# 802.1CB and Qci Layering

Christian Boiger  
christian.boiger@b-plus.com  
IEEE 802.1 Interim  
September 2015  
San Jose, CA

# 802.1CB with 802.1Qci as shown in 802.1CB D1.1 C.3

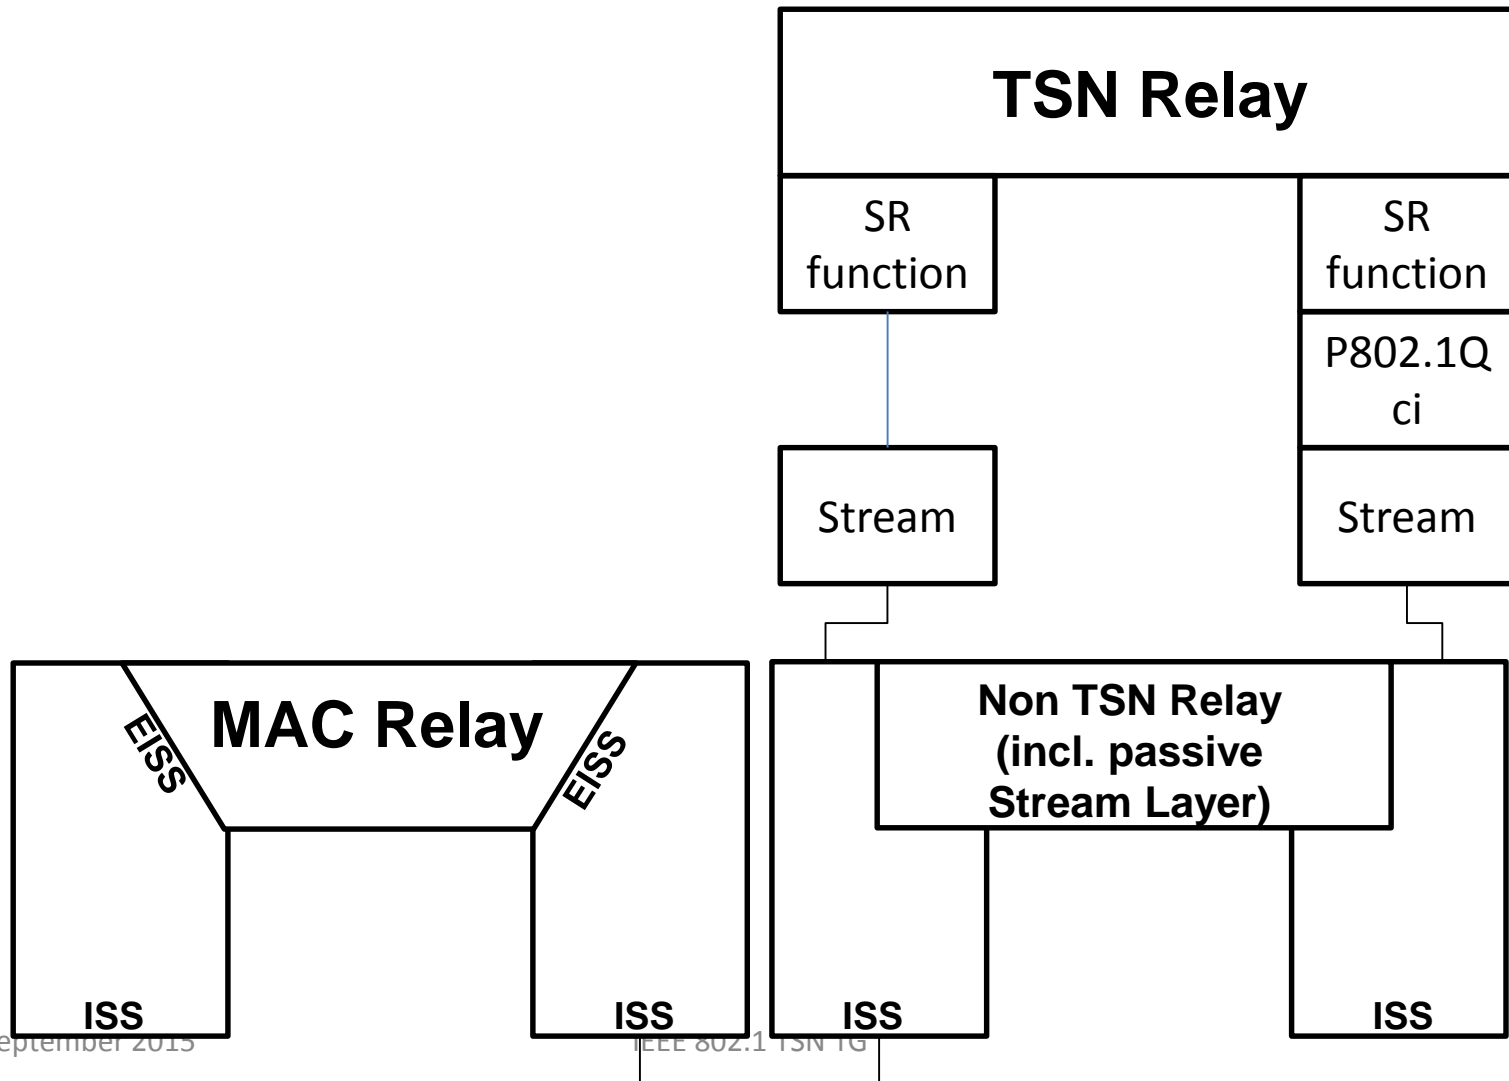
- The stream identification is needed for 802.1Qci but is defined in 802.1CB (Seamless Redundancy) so parts of Qci need to be in the MAC Relay
- 802.1CB defines that 802.1Qci is used outside the MAC Relay
- This seems to be not a very clean approach and is very confusing for the reader
- Does this mean that there is an additional separate implementation of Qci necessary for each port besides the Qci implementation in the MAC Relay?
- In the CB layering approach the Qci implementation is above the Non TSN Relay -> so the Qci implementation on this side only supports TSN streams?

## Issues with the current proposal

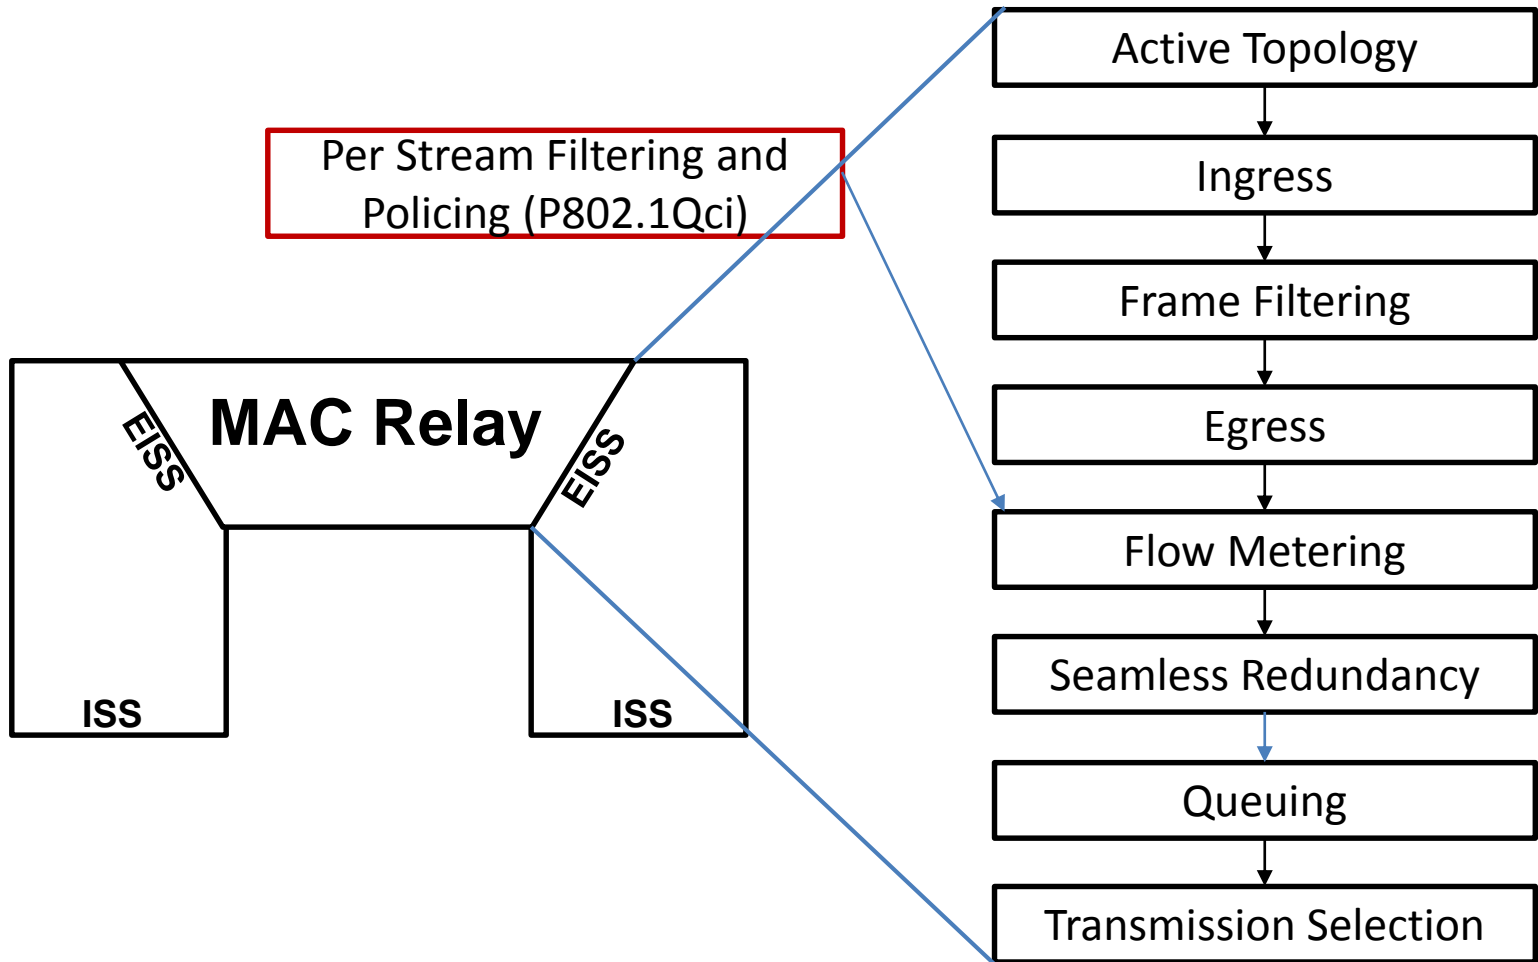
- The main problem of the current approach of 802.1CB seems to be that it tries to define the “whole world of TSN” for all layers (incl. layer 2, 3, 4)
- For seamless redundancy this is not necessary
- Seamless redundancy requires a sequence number, currently this sequence number is encoded in a layer 2 tag
  - layer 2 is required for Seamless Redundancy as defined today
  - there is no reason to try to put layer > 2 related topics in CB (for seamless redundancy)

- Get rid of the “Popeye arm” for seamless redundancy, it is not necessary
- All of the seamless redundancy related functions can be handled inside the MAC Relay
- The identification of streams can be based on layer 2 fields as it is done for AVB
- “But we want to tunnel/proxy layer  $\geq 3$ ”
  - Yes, but this is completely orthogonal to seamless redundancy
  - Proxying other traffic is a completely different topic
  - The “Popeye arm” can be used as a middlebox for TSN unaware end stations
